**Sampling and Analysis Plan  
Amendment Number 2  
Operable Unit 2C  
Landfill Sites 3 and 5  
FORMER MARINE CORPS AIR STATION, EL TORO,  
CALIFORNIA**

**SUBJECT: FINAL SAMPLING AND ANALYSIS PLAN AMENDMENT NUMBER 2,  
OPERABLE UNIT 2C, LANDFILL SITES 3 AND 5, FORMER MARINE  
CORPS AIR STATION, EL TORO, CALIFORNIA**

**Appendix D**  
**Response to Comments**

SAP Amendment #2		Final
<b>Site 5 - Supplemental Sampling Locations</b>		
Date: 02-04	Former MCAS EI Toro	
Project No. 37380	 EARTH TECH	Figure A-2
A tyco INTERNATIONAL LTD. COMPANY

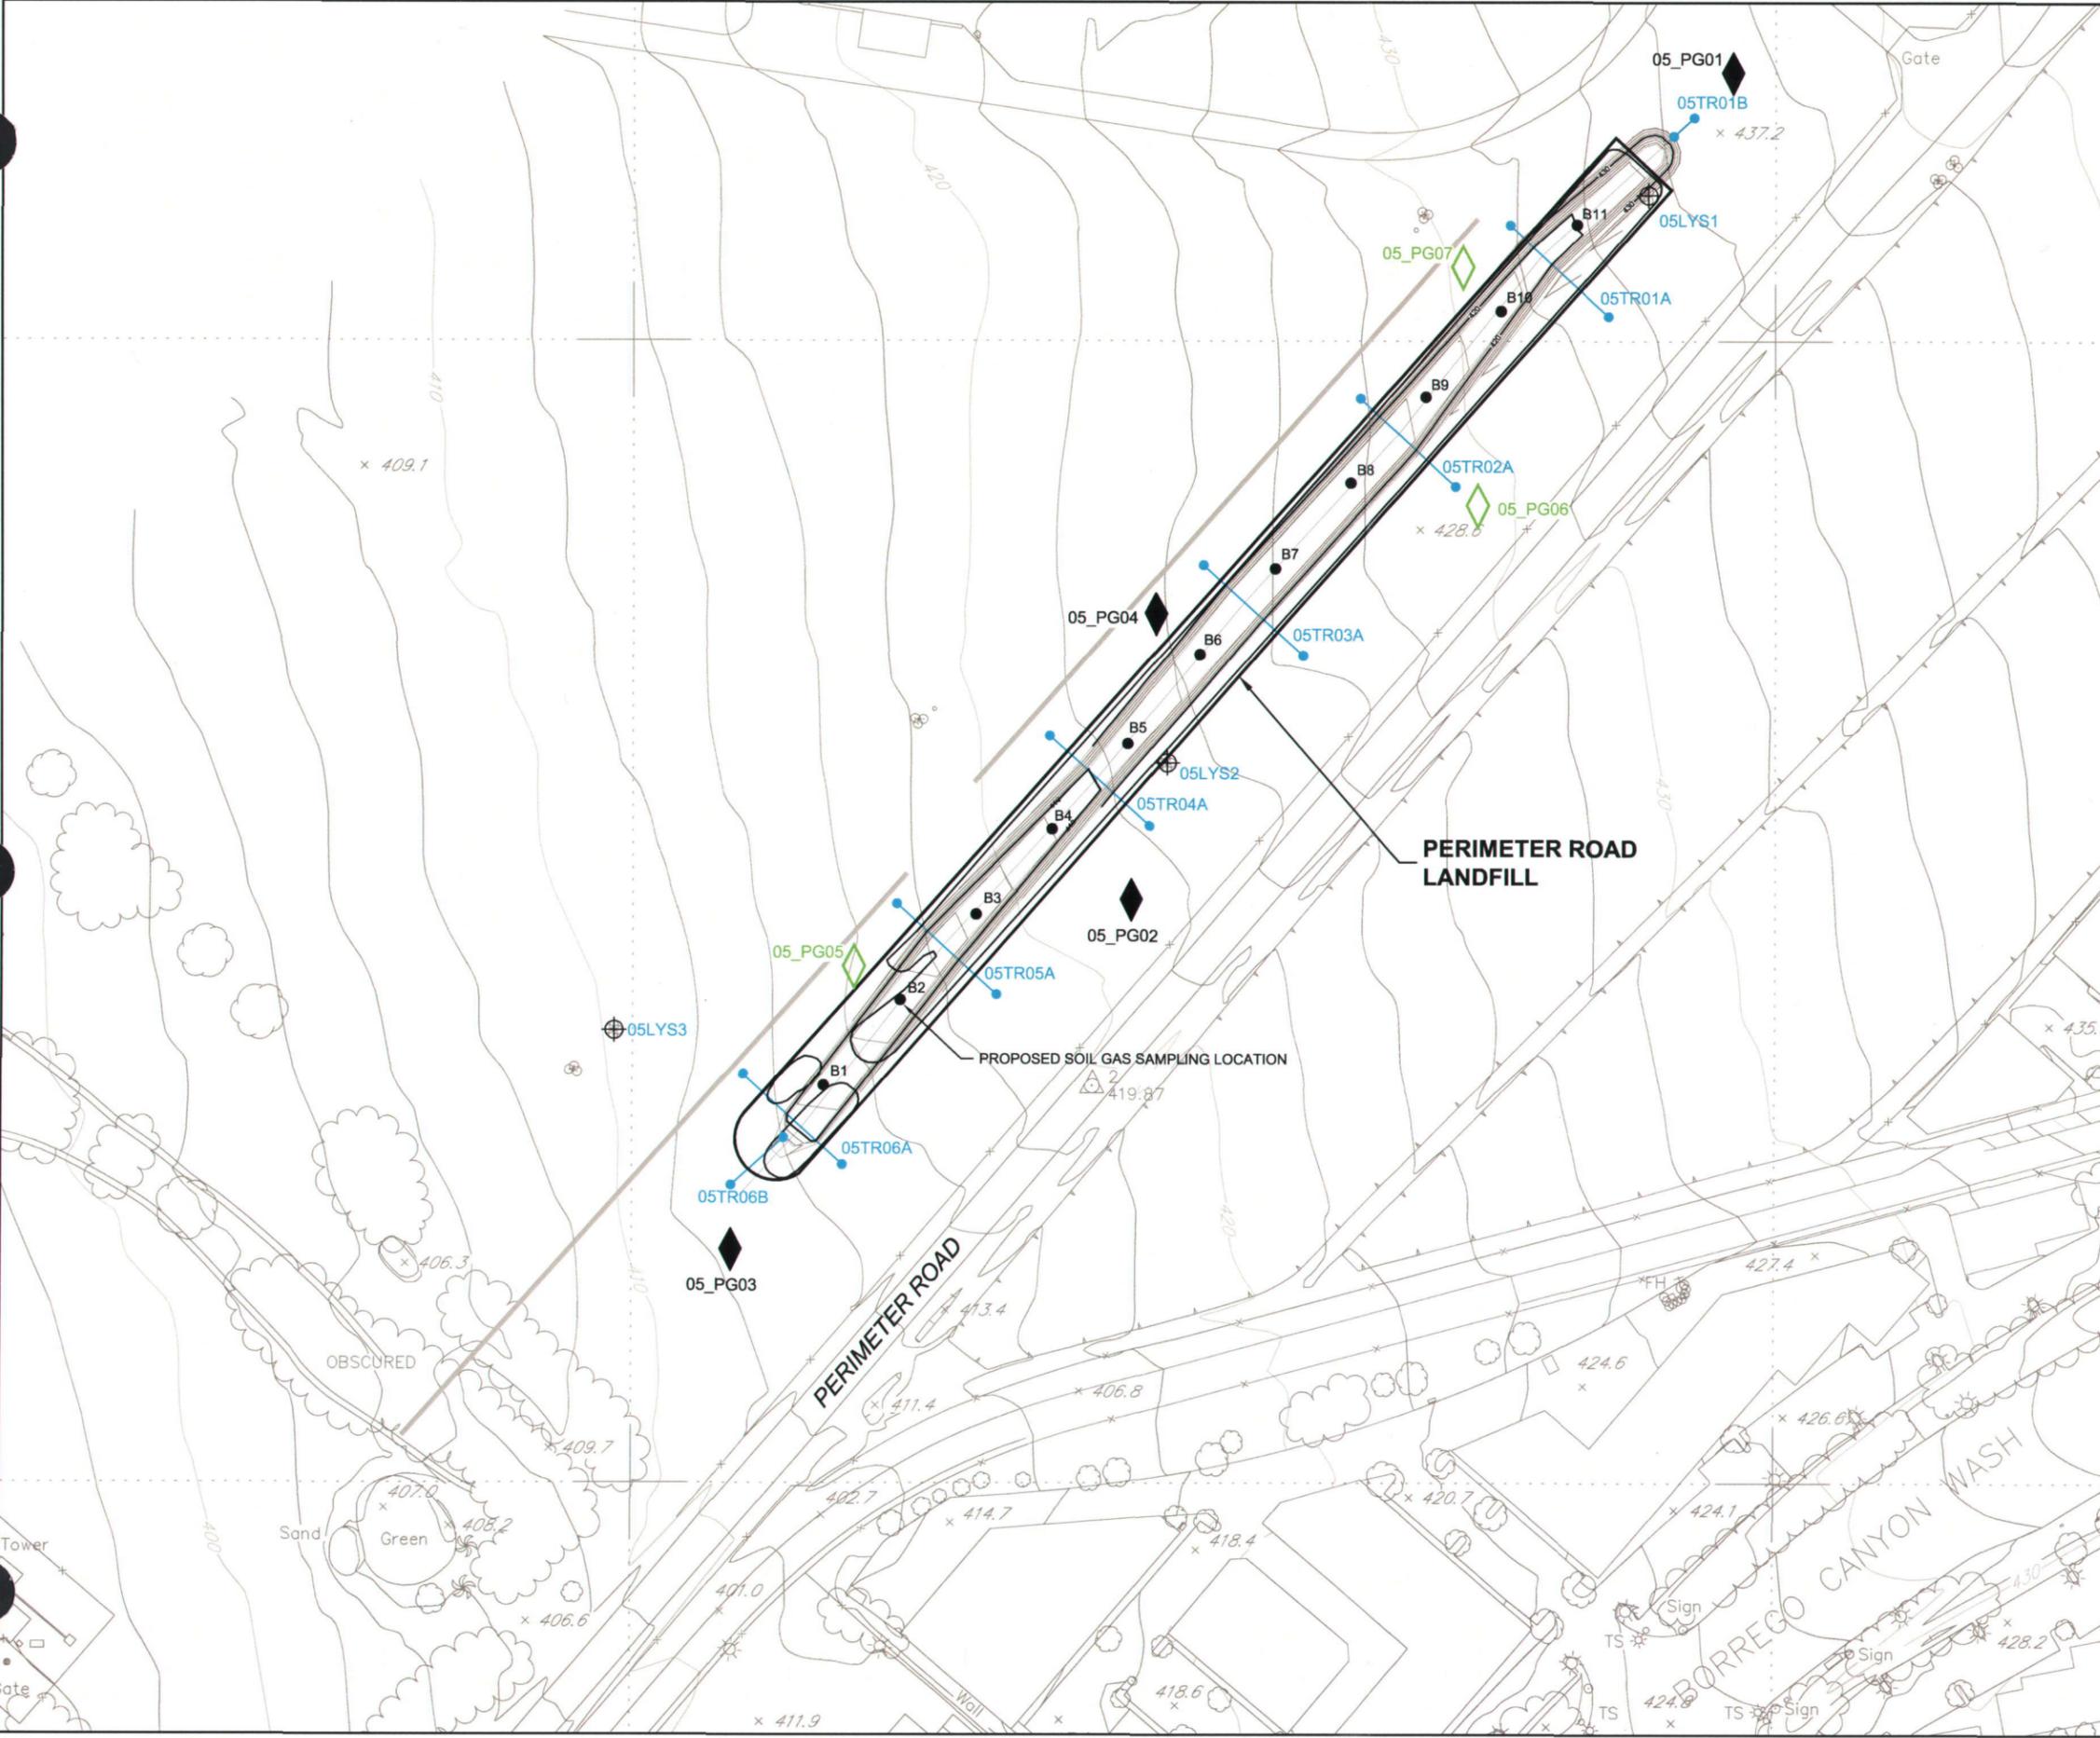
2.		GSU is concerned that the language of the Addendum is unclear with respect to proposed soil vapor well installation at Site 5. The contractor should clarify exactly which wells will be installed in this investigation and which wells will only be installed based on field findings.	Four proposed perimeter soil vapor monitoring wells will be installed at Site 5 (wells 05_PG01, 05_PG02, 05PG03, and 05_PG04, as shown in Figure A-2 of the SAP Amendment). Consistent with the DQO decision rules, if any landfill gas sample (direct push probe location) has a methane concentration greater than 5-percent, three additional perimeter soil vapor monitoring wells (05_PG05, 05_PG06, and 05_PG07, as shown in Figure A-2 of the SAP Amendment) will be installed to monitor landfill gas migration. The pertinent language is clarified in the revised Addendum.

Figure A-3: Typical Vapor Well

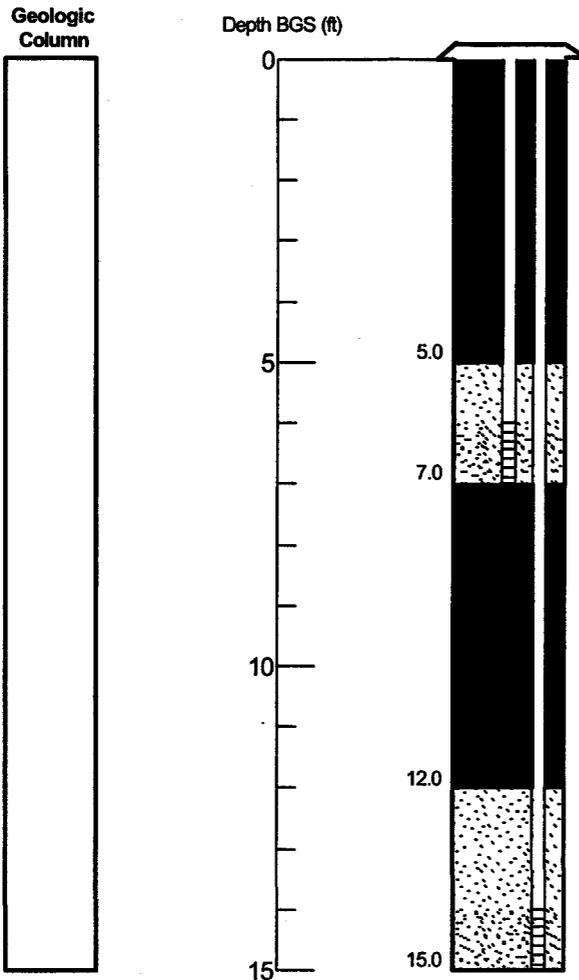
6.		GSU concurs with the adoption of Title 27, Division 2, Section 20925 well requirements. GSU requests that the specific construction details follow the requirements of Sections 2.2.4 and 2.2.5 of the attached guidance.	Comment noted. Monitoring well construction details follow the requirements of Sections 2.24 and 2.25 of the DTSC guidance document. This has been incorporated into the SAP Amendment.
